**City of Bellevue
Development Services Department
Land Use Staff Report**

Proposal Name: The Reserve at Phantom Lake Short Plat

File Number: 22-112080-LN

Department Decision: Approval with Conditions

Figure 4. Public Comment supplement

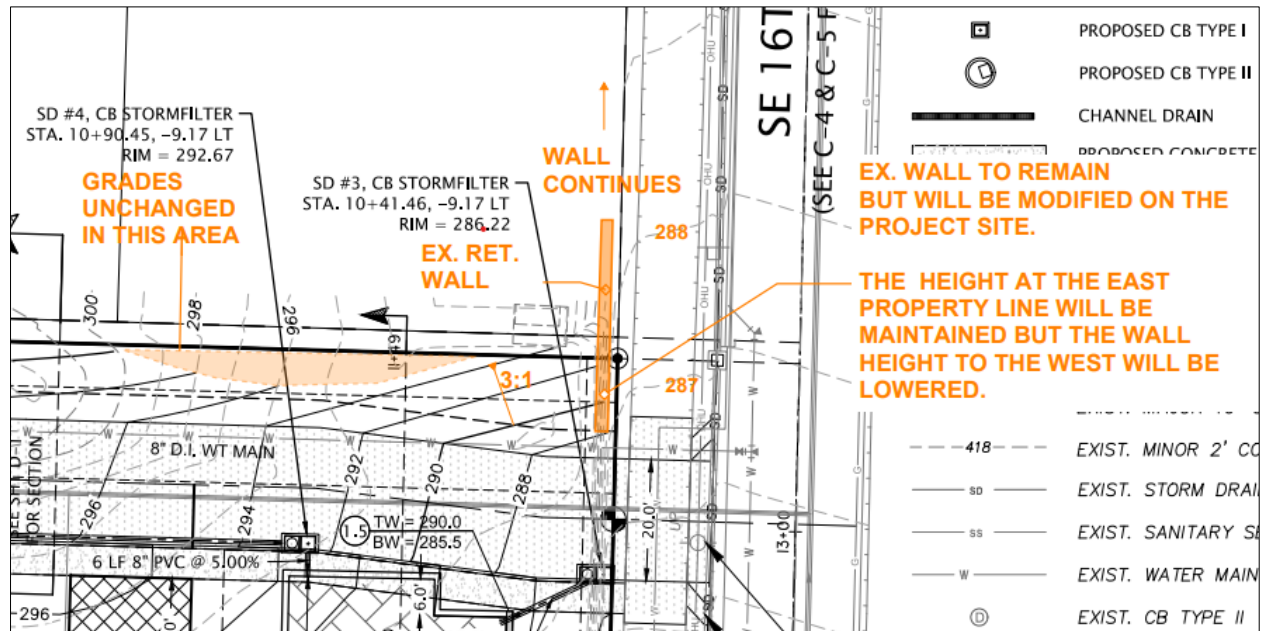
Comments identified concerns related to soil type and the addition of retention walls for long term stability. Specific concerns are related to the grade change at the intersection of SE 16th St and the newly proposed private access.

Comment identified concern about existing fence on their property which will run adjacent to the proposed new access road for the short plat and how grading may impact their fence.

Finding: The grading area of concern is depicted in **figure 4**. The existing retaining wall fronting SE 16th St will remain and modified only as indicated in the graphic. The eastern portion of the wall will remain at its existing height while the height will be reduced moving farther west and toward the proposed access road. The project geotechnical engineer has reviewed the grading plan and supports the design.

Finding: The proposal will provide a 6-foot Cedar fence along the subject property line and adjacent to the access road. The fences on the properties to the east will remain. Grading will take place to match the existing grades on site and soil erosion measures will be in place. Conditions will be monitored, and further soil erosion control measures will be employed, if necessary. Much of the area in question will remain largely unchanged/ungraded as indicated in **figure 4**.

STORM DETENTION VAULT
CONTROL STRUCTURE

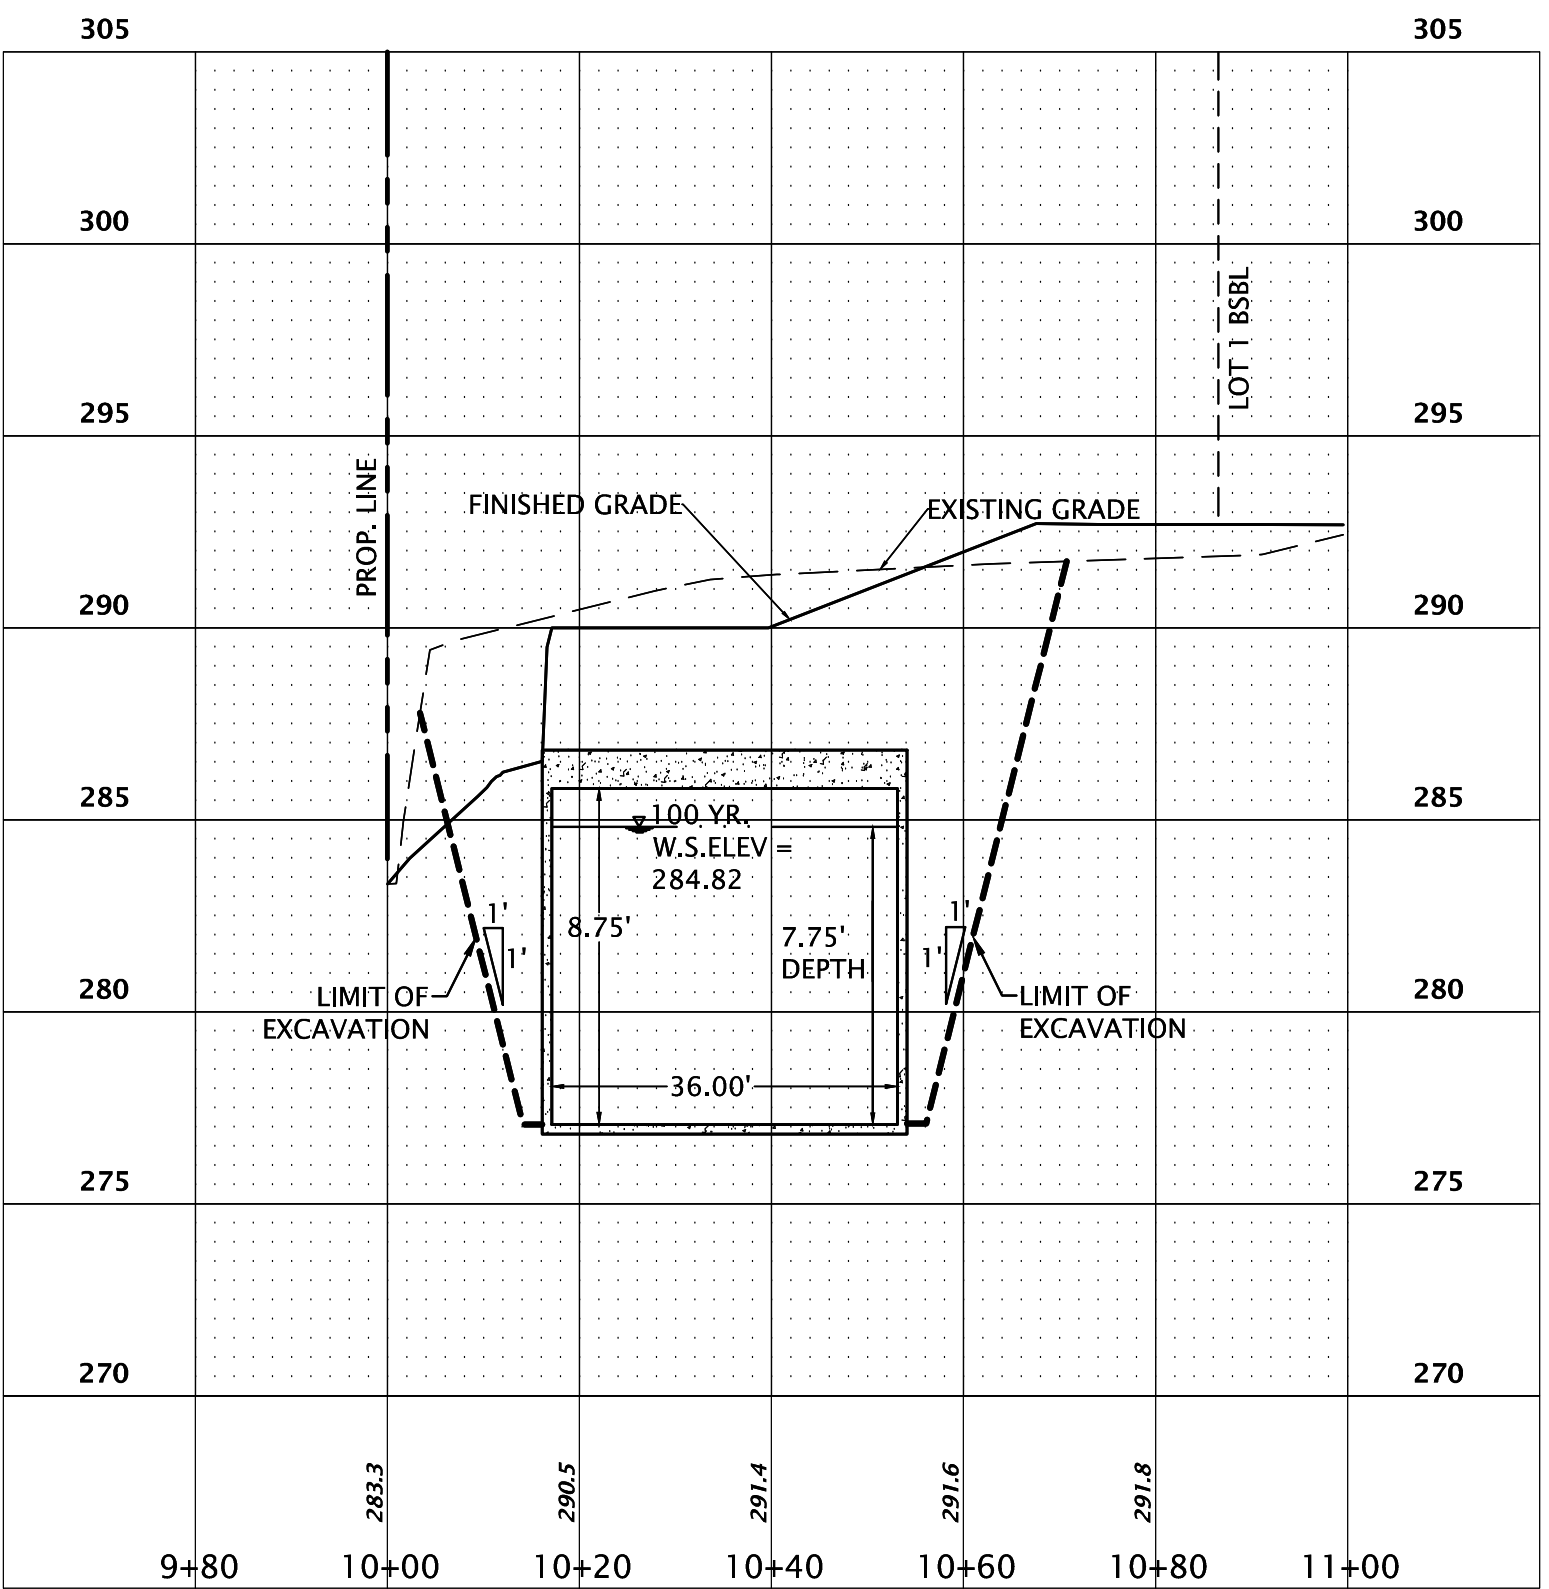
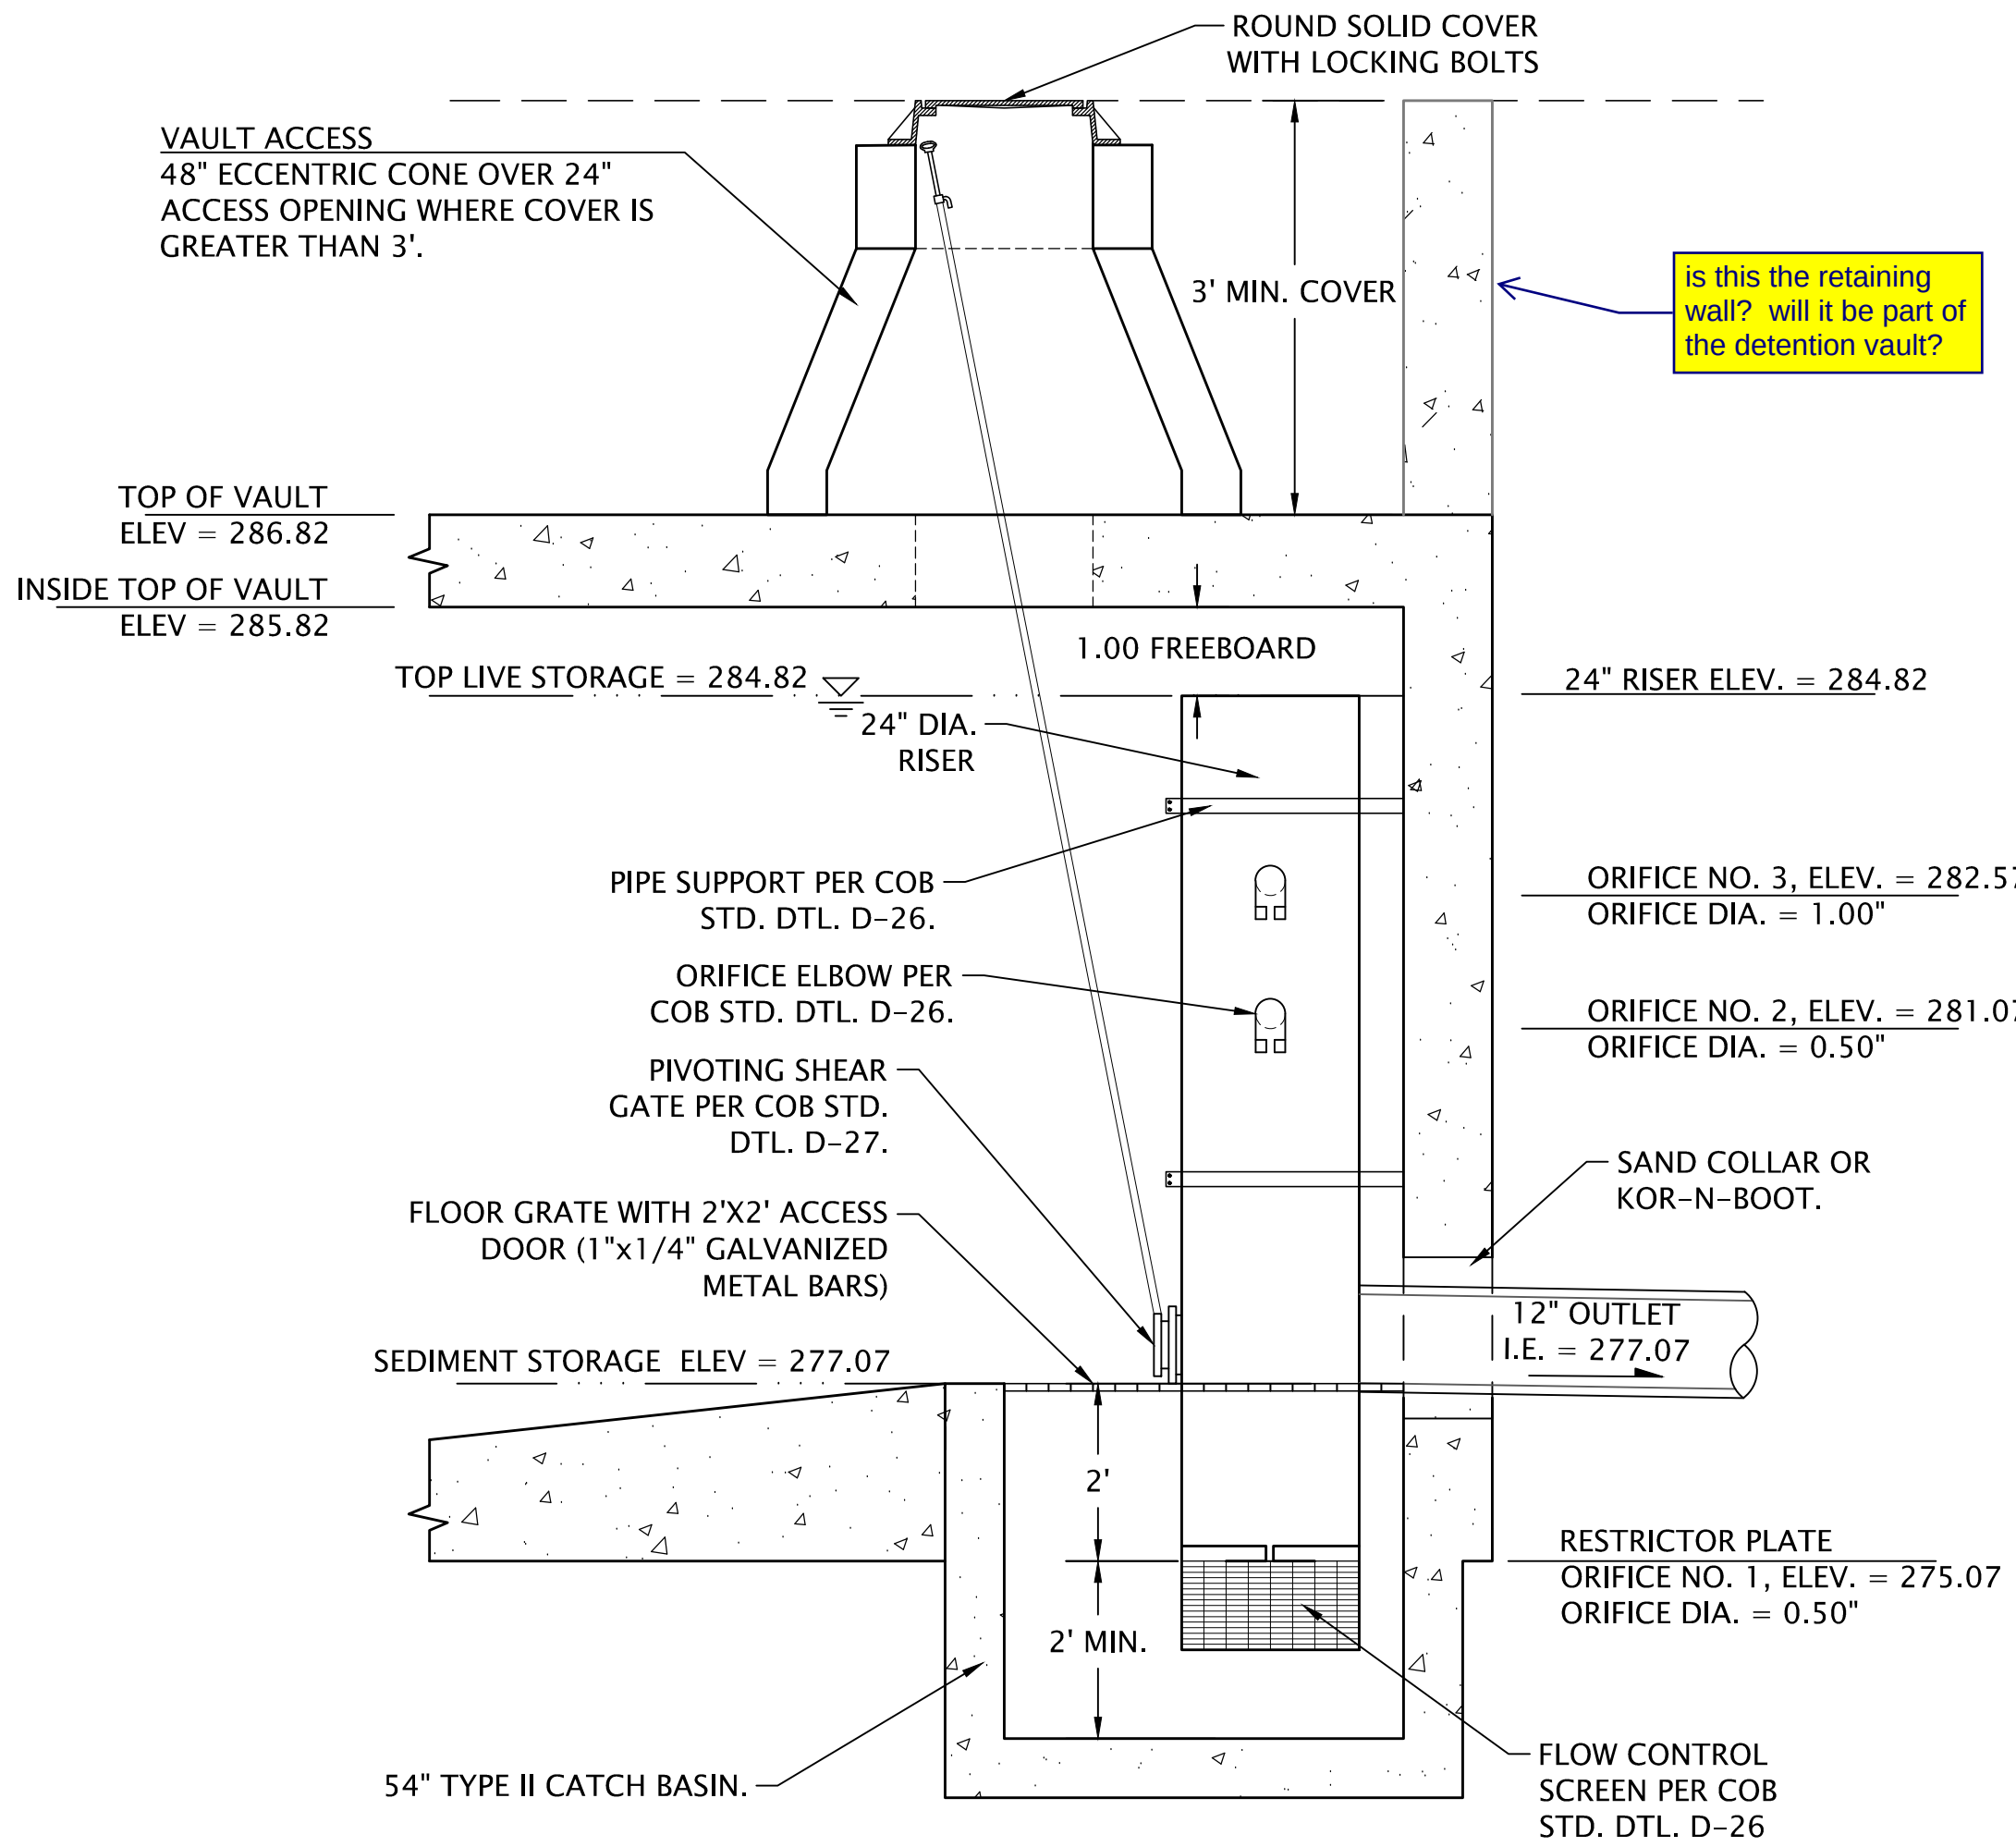
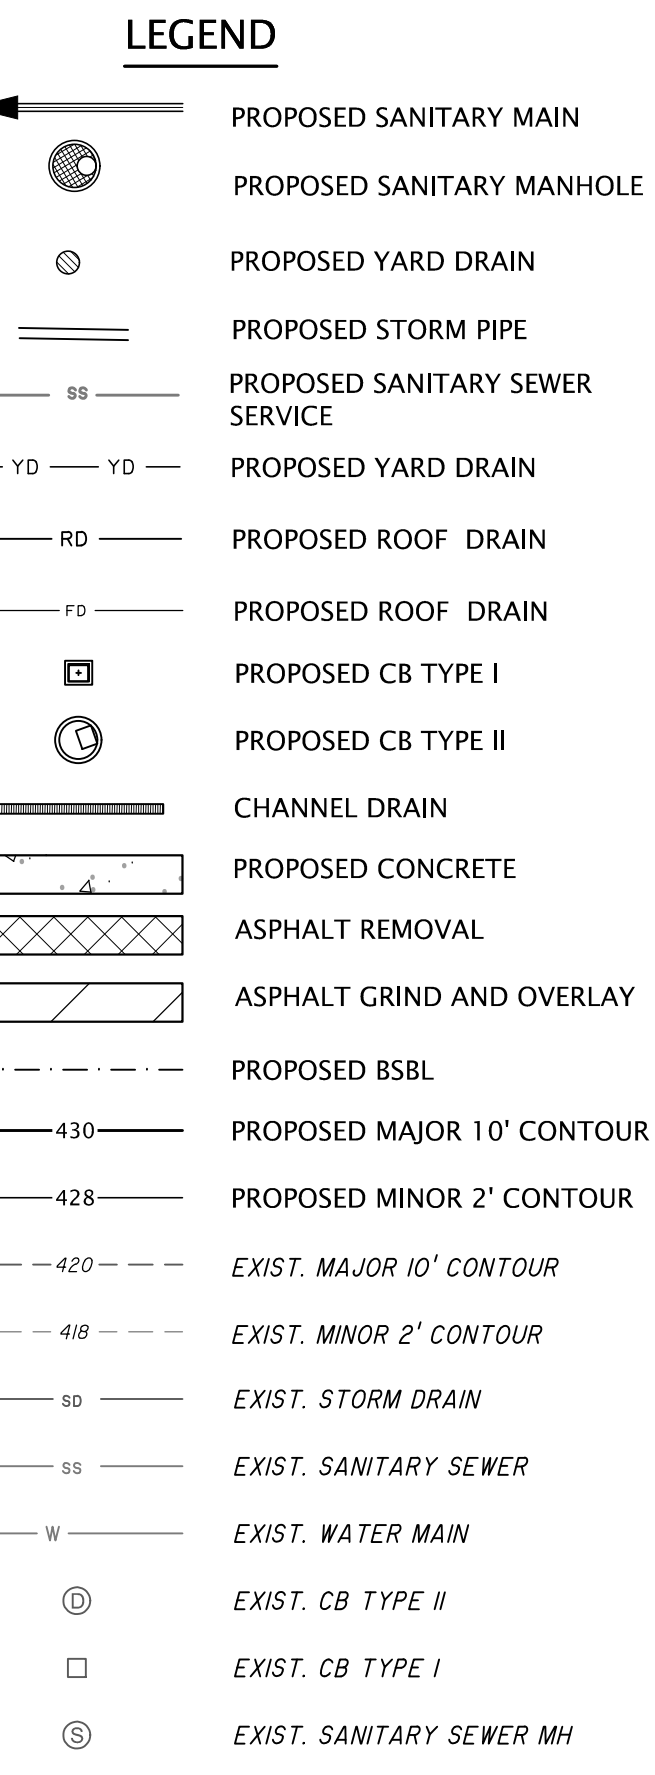
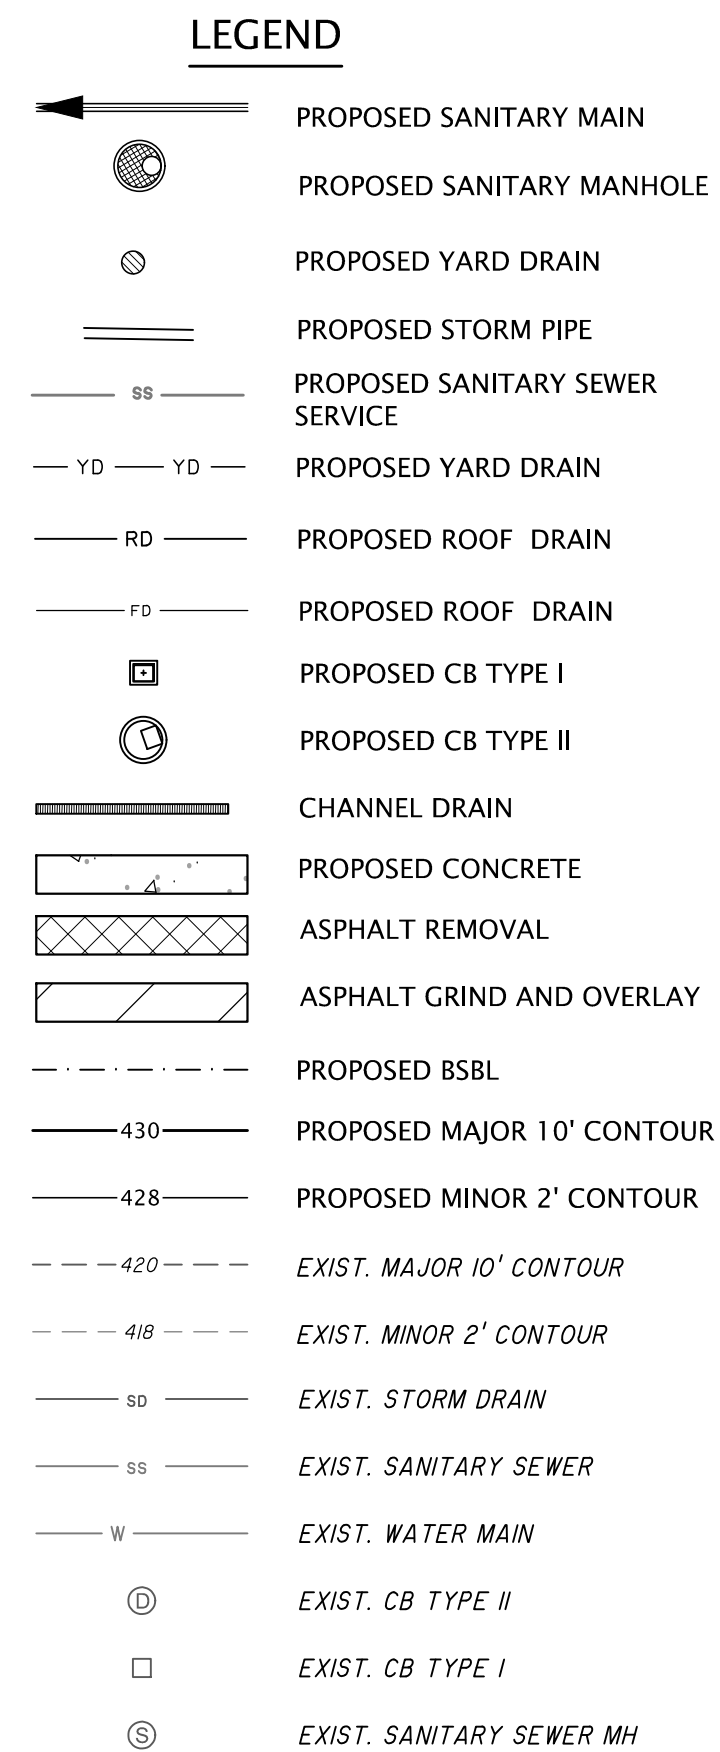
is this the retaining
wall? will it be part of
the detention vault?
